Door closure Sound Improvement

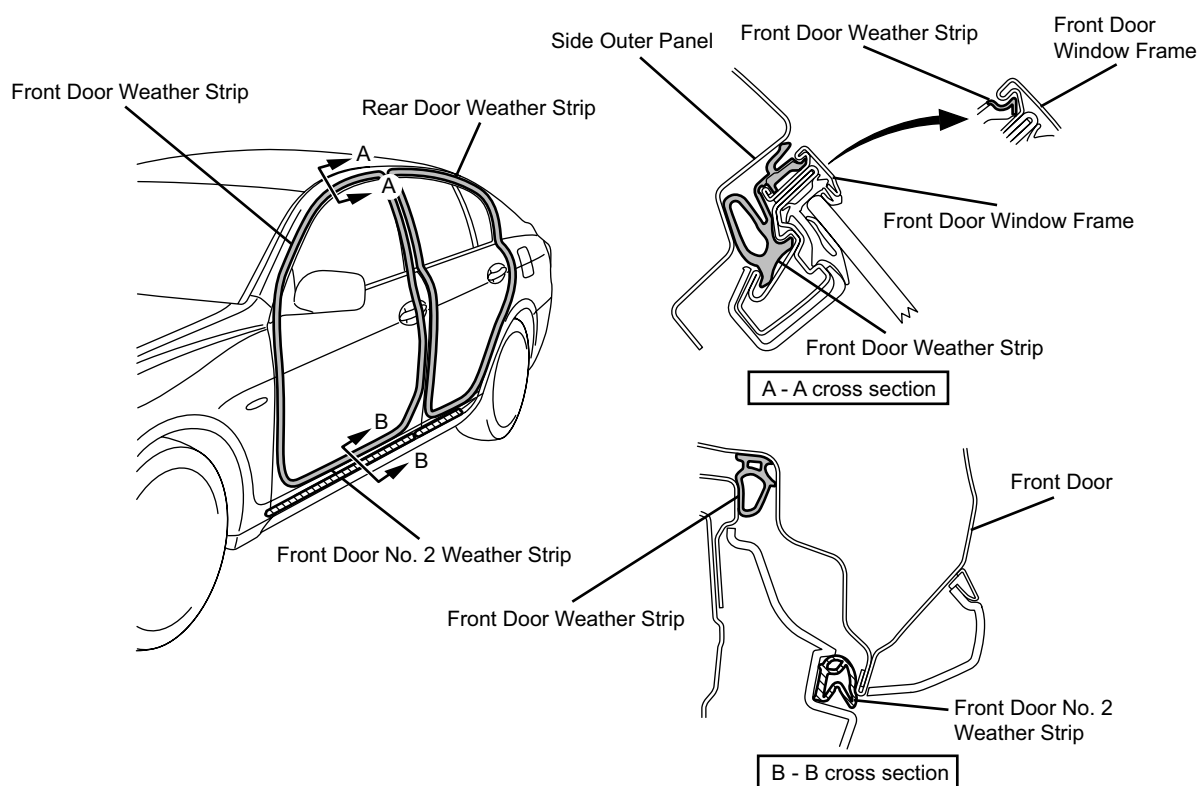
- A sponge layer is provided to the front and rear door weatherstrips in order to reduce the rattling sound that is created when the door comes in contact with the door window frame as the door is being closed (see A-A cross section).
- A hollow front door No. 2 weatherstrip is provided at the rocker in order to reduce the sound that is created when the door is being closed (see B-B cross section).
